EAST ROSWELL LIBRARY
ADDENDUM NO. 26.1-2
APRIL 22, 2013

This Addendum No. 26.1-2 dated April 22, 2013 issued by Ajax Building Corporation of Georgia is hereby made part of Bid Package 26.1 – ELECTRICAL for the East Roswell Library. The changes and/or clarifications included in this Addendum shall be considered as part of the Bidding Documents and shall supersede, amend, add to, or subtract from those conditions included in the original Bidding Documents, including the Project Bid Package, Drawings, Specifications, previous Addenda, etc. This Addendum must be acknowledged in the space provided on the Proposal Form (included in Section II of the Bid Package). Failure to acknowledge this Addendum may subject Bidder to disqualification.

East Roswell Library

ADDENDUM NUMBER ONE

UTILITY PLAN

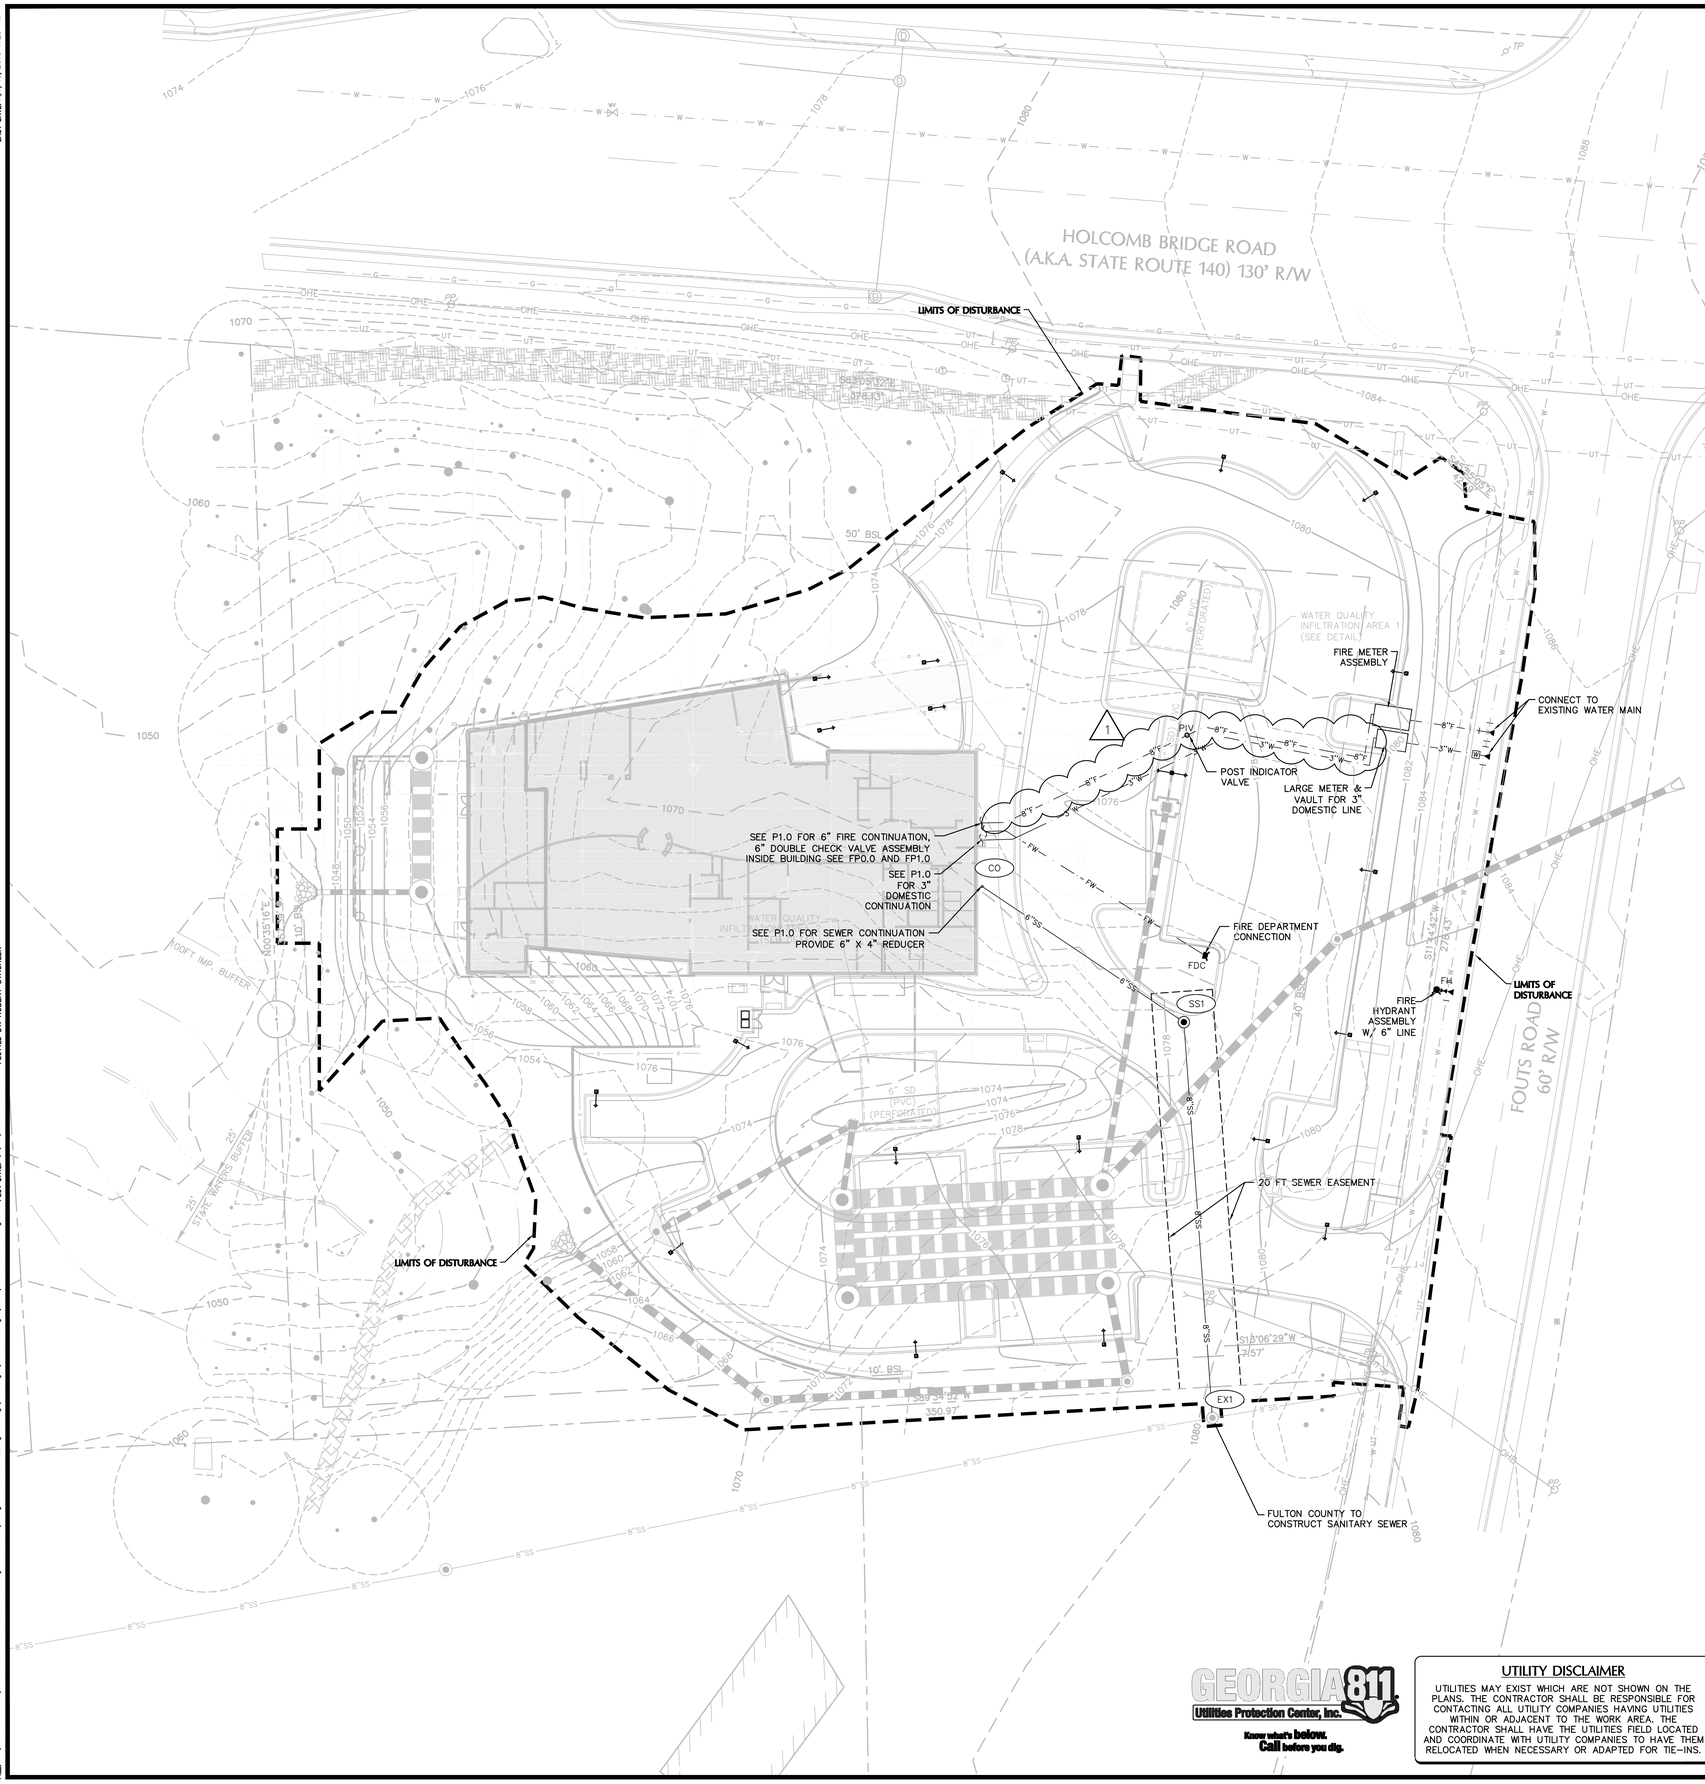
1. The following sheets are issued herewith:
   a. C-500 Utility: delete the sheet and replace with the attached sheet. The fire line between the fire meter assembly and the building has been upsized from a 6-inch line to an 8-inch line.
   b. FP0-0 - Fire Protection Legend, Schedule and Details: delete the sheet and replace with the attached sheet. Detail 4 – Added a 6" tag to the outgoing line on the Double Check Valve Assemblies Detail, DCVA, and changed the incoming fire line size from 6" to 8" on the same detail.

1 BASEMENT FLOOR PLAN - FIRE PROTECTION
1/8" = 1'-0"

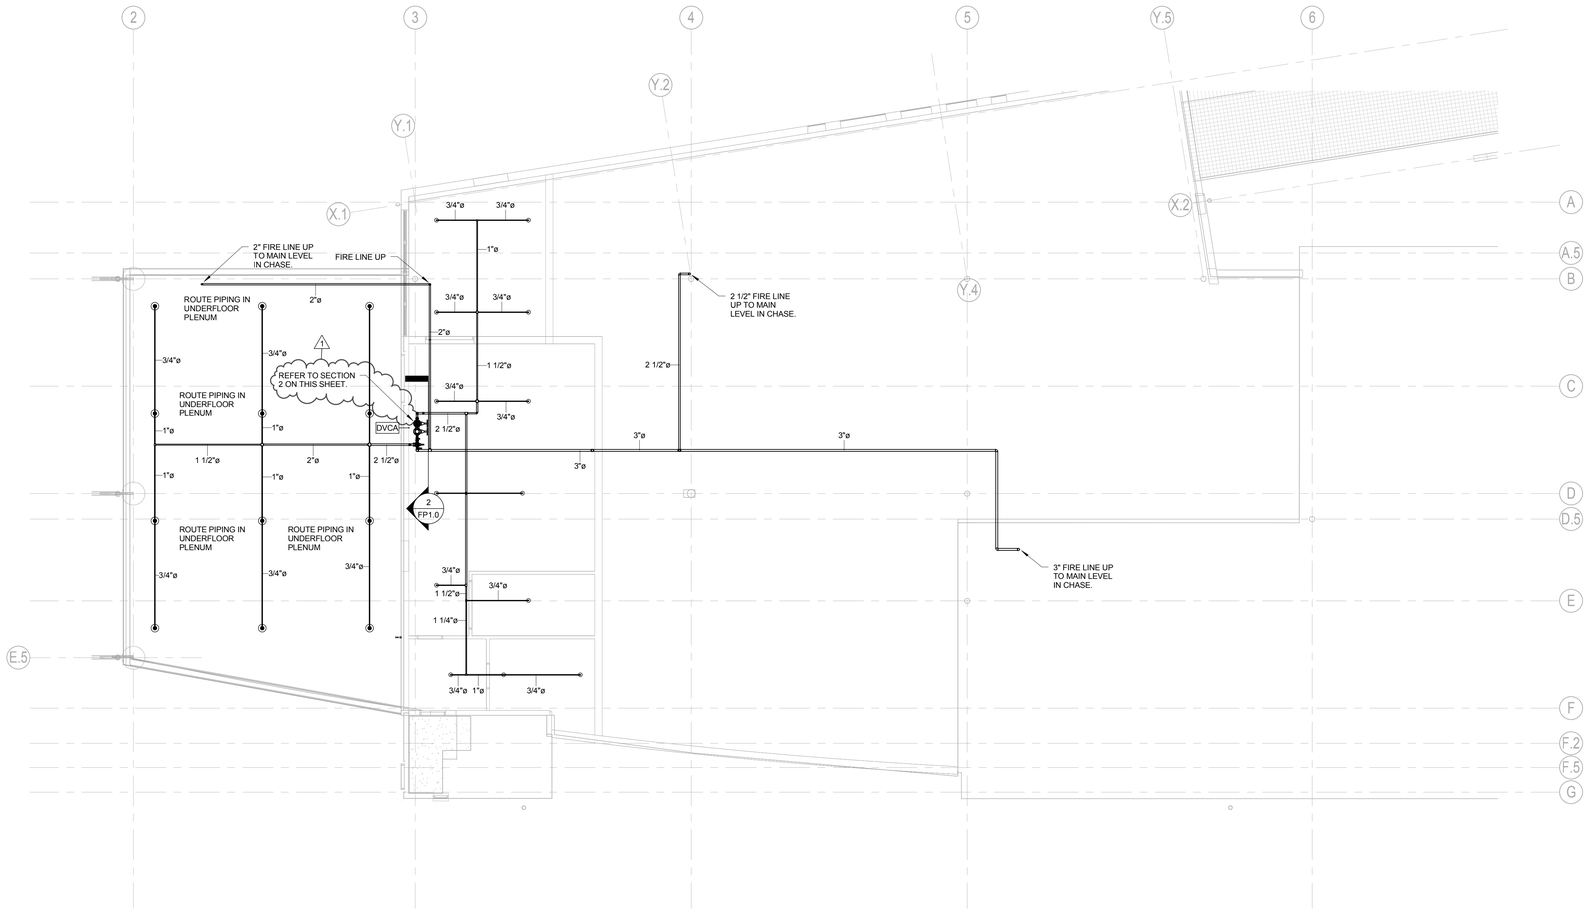
c. FP1-0 - Basement Floor Plan - Fire Protection: delete the sheet and replace with the attached sheet. Plan - Changed the note pointing to the DCVA to read as follows: "Refer to Section 2 This Sheet."
